Caledon Pit & Quarry

18722 Main Street, Caledon, Ontario

Existing Features

The redline revisions shown on this drawing represent all of the changes that have been made since the August 2023 and July 2025 Aggregate Resource Act site plans. The changes shown in blue are revisions made to the July 2025 site plan.

Noise Mitigation Schematic

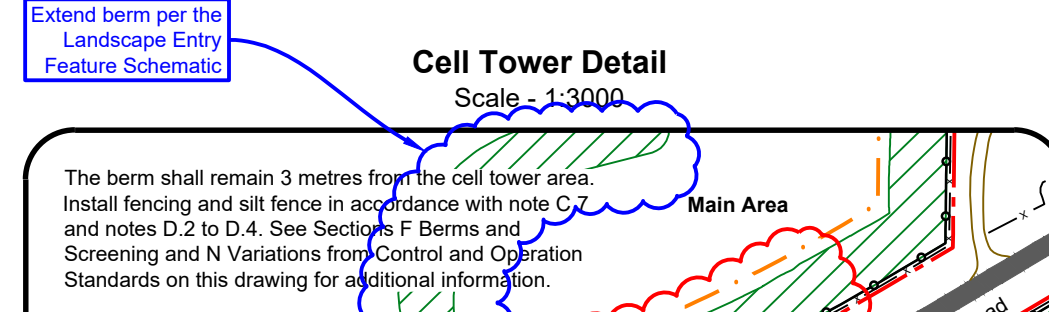
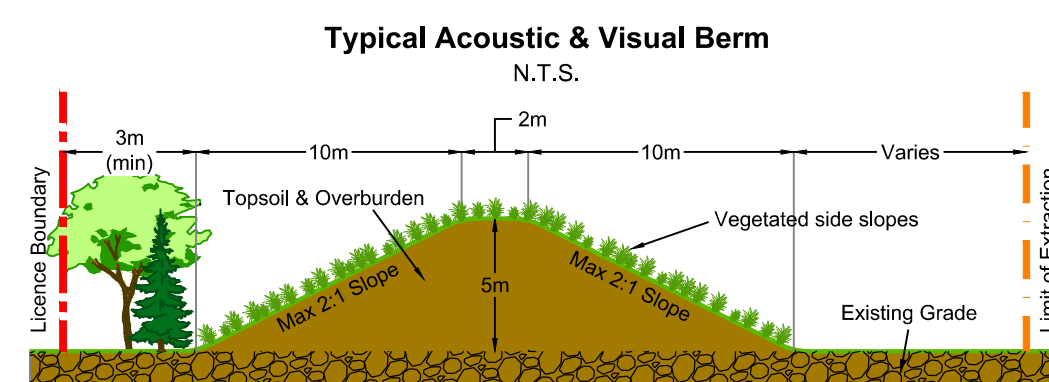
Move Table 3 from previous drawing 3 of 4 to this drawing

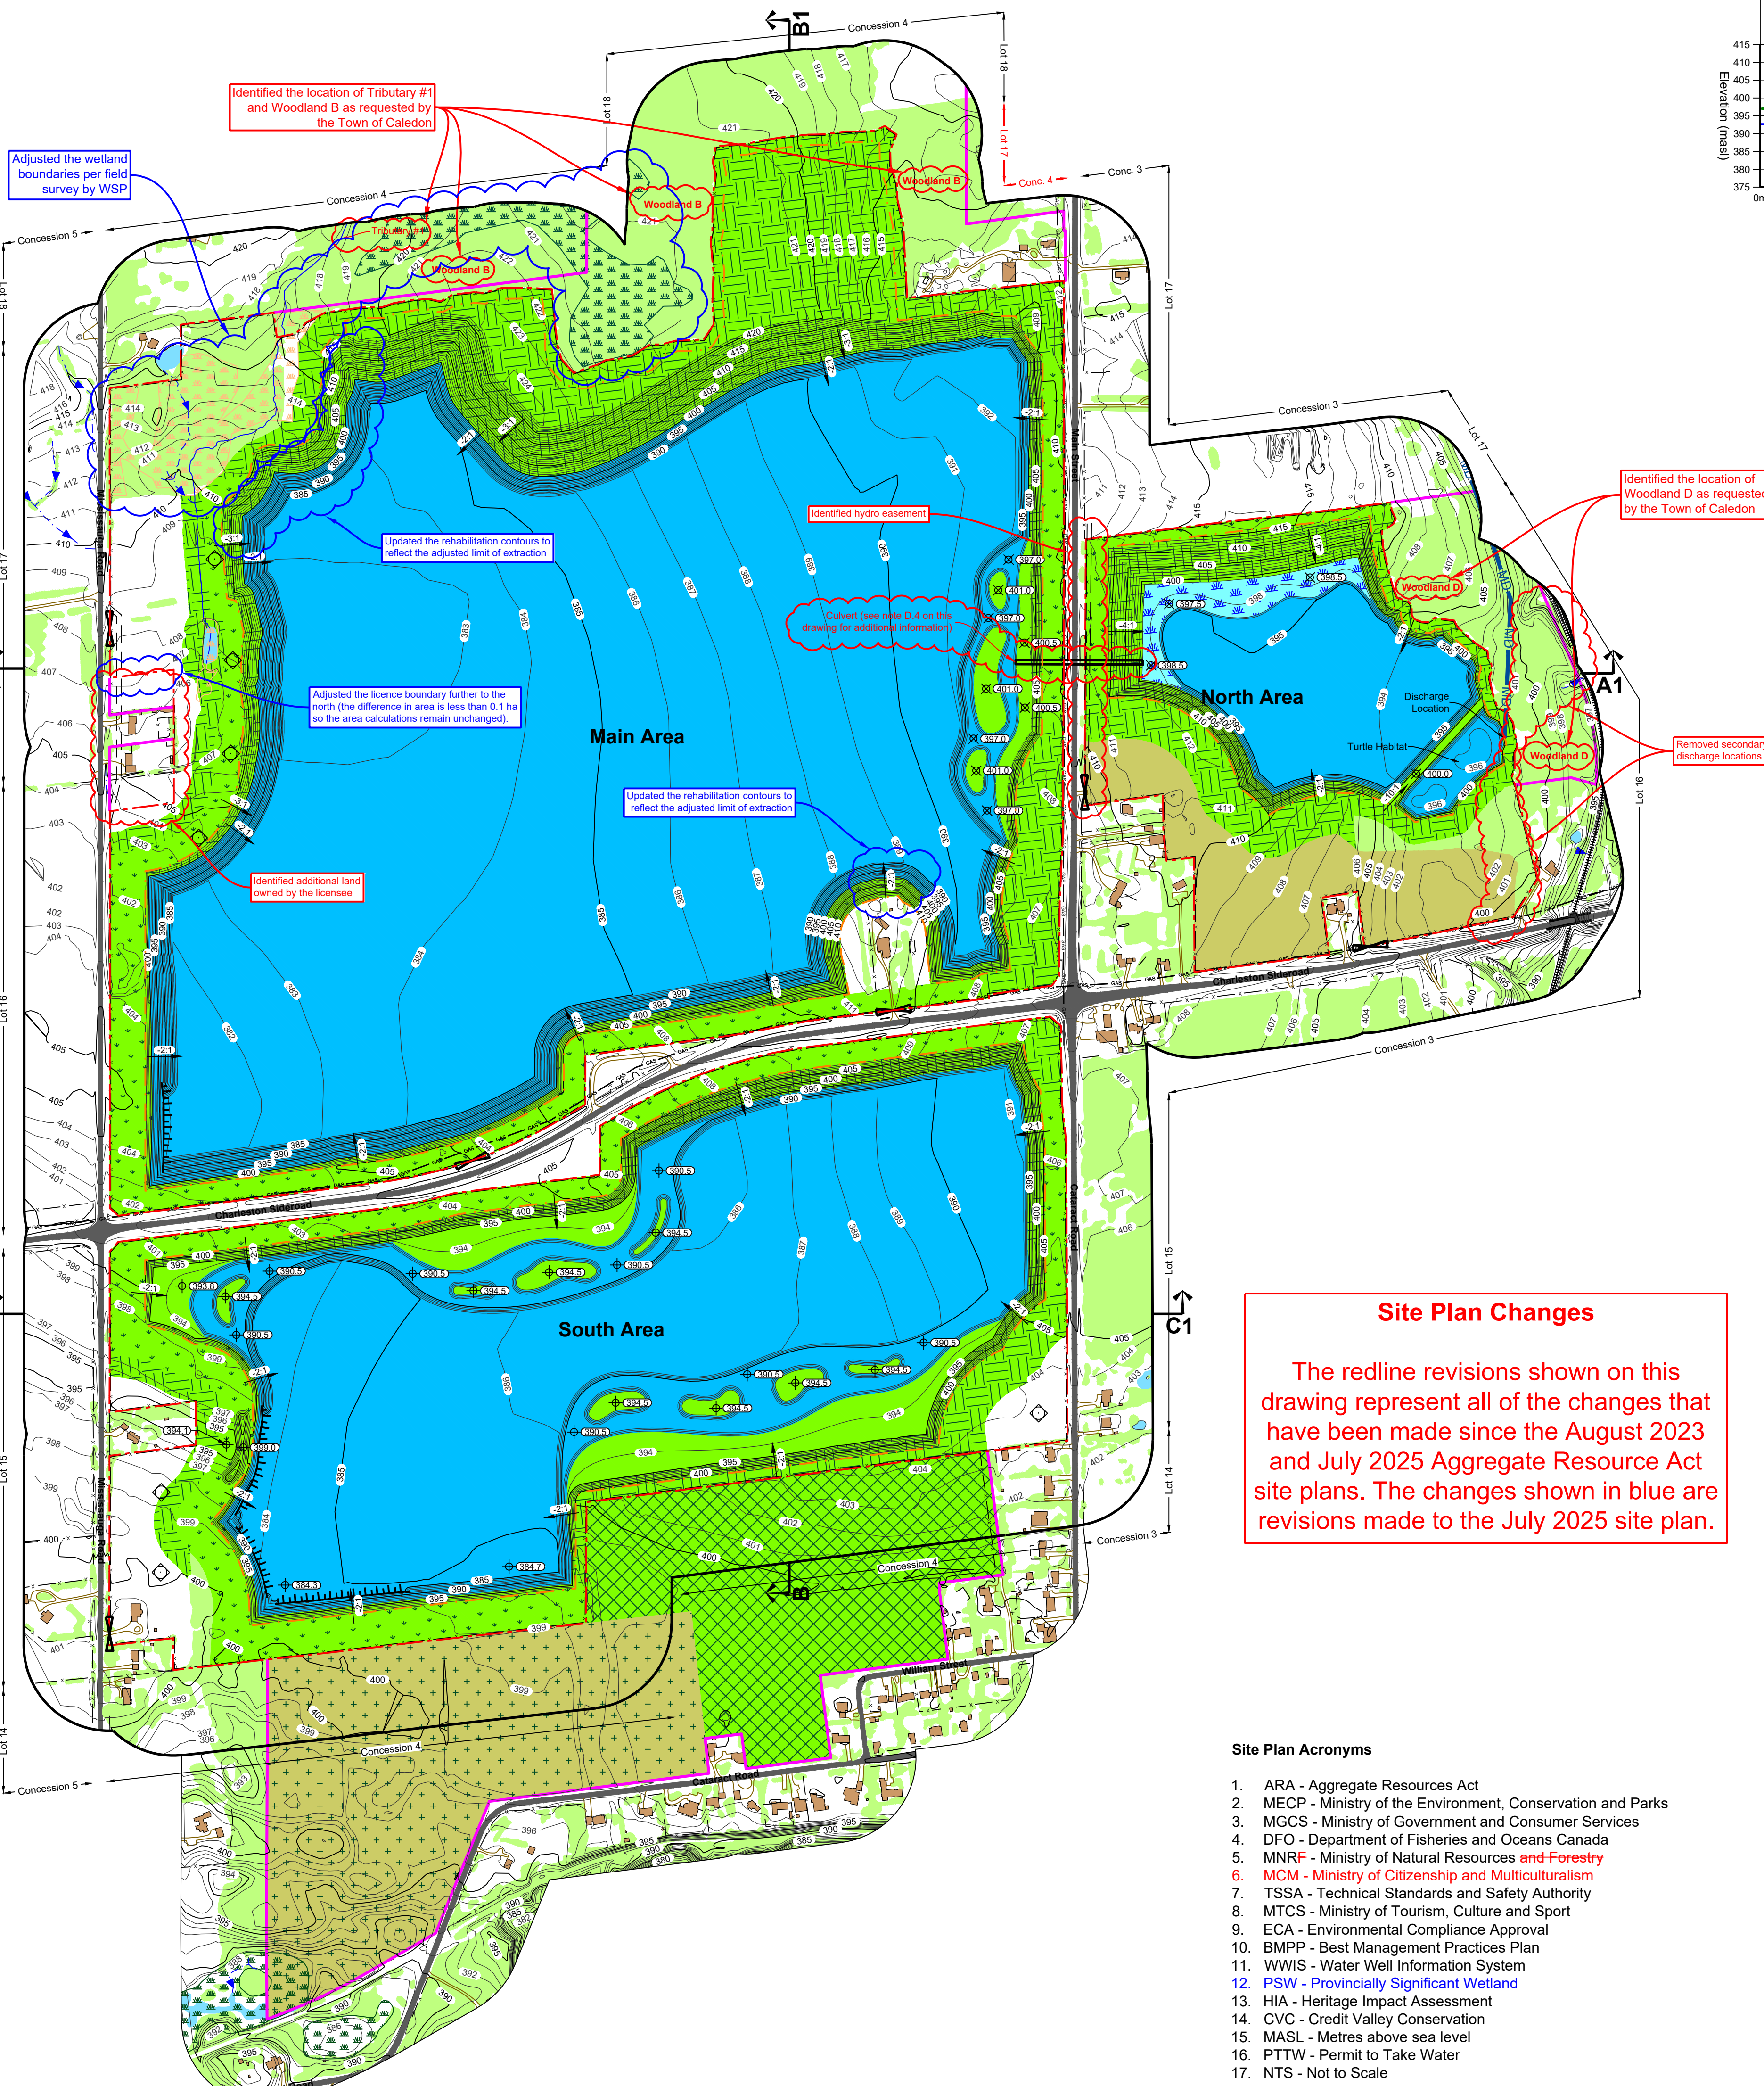
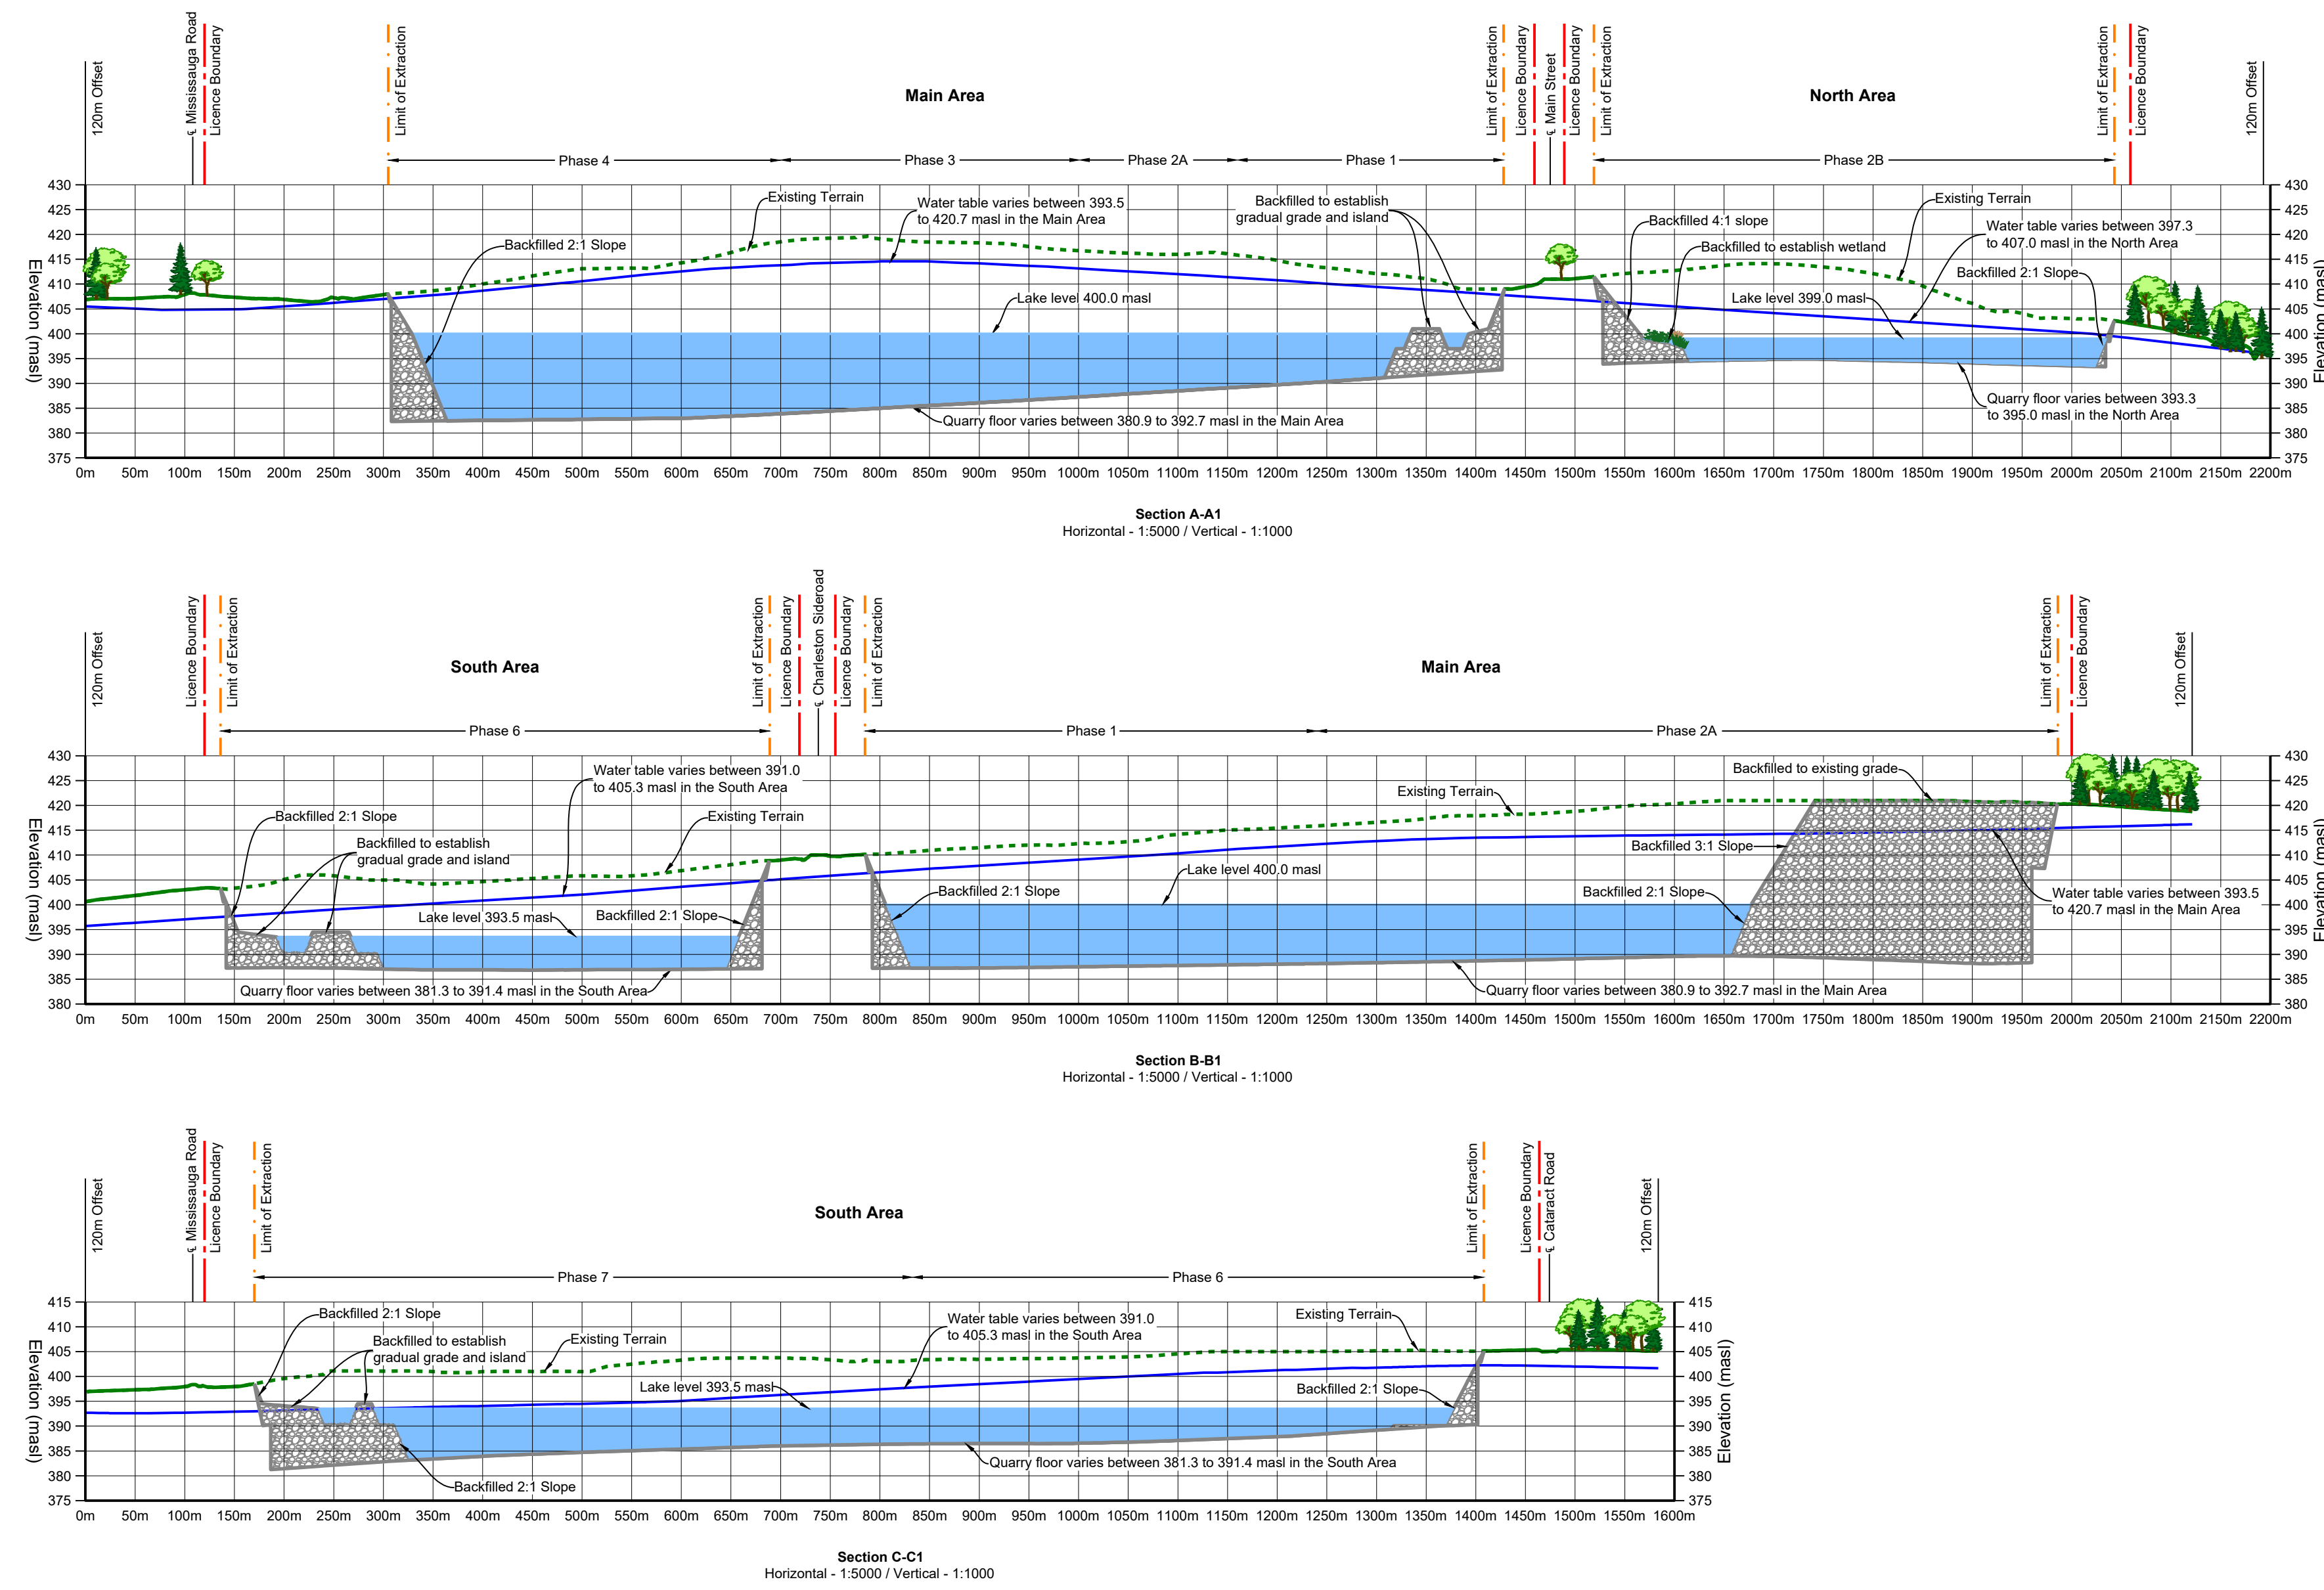
The redline revisions shown on this drawing represent all of the changes that have been made since the August 2023 and July 2025 Aggregate Resource Act site plans. The changes shown in blue are revisions made to the July 2025 site plan.
